From: Robert Adams <cra_arc@hotmail.com>
Sent: Thursday, January 2, 2025 5:17 PM
To: PL, Subdivision and Zoning
Cc: Michelle Adams
Subject: Comments for Case C-7706 (Hearing: 01/09/2025)
Attachments: C7706 Site Views_Adams.pdf

Pertaining to the Final Plat of Piedmont Intermediate on Memorial, I wanted to express a few concerns to the board for consideration:

Case C-7706 Site Views

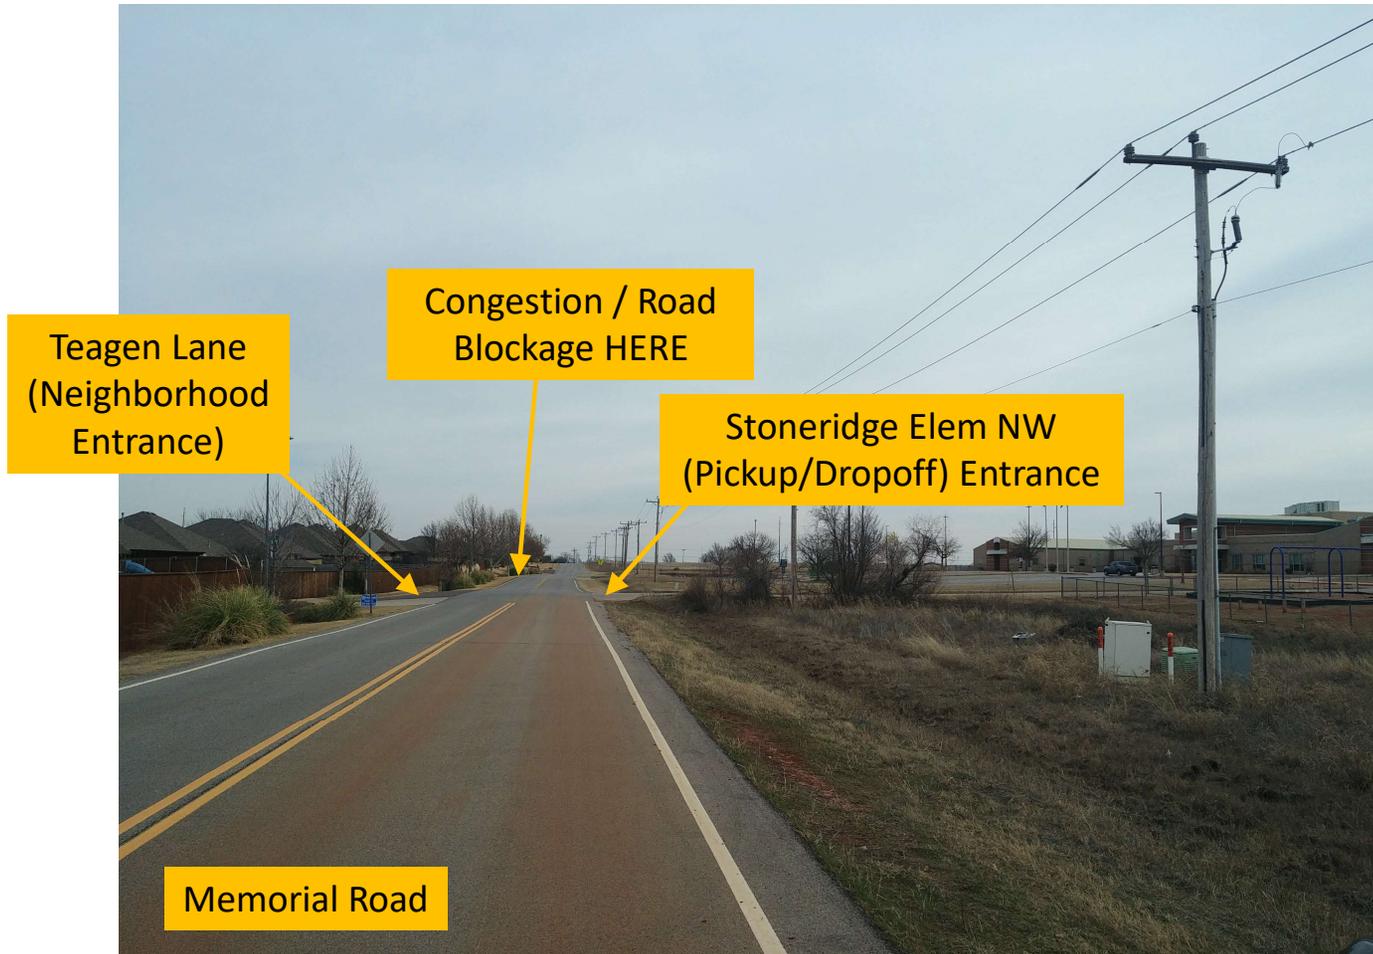
1. **Traffic @ Stoneridge Elementary:** Memorial Road is a two-lane undivided road which experiences significant congestion (becomes impassible without driving through the neighborhood) on school days. The addition of another school will exacerbate this issue. Widening the road to add more lanes or a turn lane could remedy this situation.

2. **Traffic @ Memorial & Morgan Intersection:** Similar to the traffic at Stoneridge Elementary, the four way stop at the intersection of Memorial and Morgan is the only way to access (one way in and one way out) Stoneridge Elementary and the proposed Intermediate. There is currently no access to NW 134th and is not suited to high volume traffic. Adding turn lanes and/or a stop light at the intersection could remedy this situation during high traffic periods.

3. **Accessibility:** Memorial Road effectively dead ends at the west end of the proposed plat - there is no path through to Sara Road to the west. I am the homeowner next door to the west of the proposed plat (at the dead end) and I am concerned about personal as well as emergency services access during periods of high traffic. With no change to the current traffic pattern, my family will not be able to access our home during pick-up / drop-off times. Given the location of the proposed plat, there is also no access to my home through the neighborhood in the event of an emergency (no entrance/exit west of Teague).

4. **Turnaround @ Dead End:** Inevitably, people will drive past the school and need to turn around (they already do without the school). The current end of the road does not have space to turn around and is not suited for any volume of traffic (mud and gravel). Adding a cul-de-sac or some other means to turn around could remedy this issue.

5. **Ponds:** There are two ponds ~100' to the west of the proposed plat along with a reservoir near-by, all of which are in the sight line of the property and will draw children. This could be remedied via a solid fence (not chainlink) and/or evergreen landscaping blocking the sight line from the proposed plat to the water. If the plat is to be approved, it would be beneficial if this was a condition for the site plan for the school.

6. **Drainage:** Currently the natural watershed drains rainwater to the NW corner of the proposed plat (toward the ponds and reservoir). Given the road is dirt at the end of Memorial, erosion will increase as result of increased runoff due to the concrete around the school. This can be resolved via careful engineering of the proposed site; however, it should be noted as part of the plat approval.
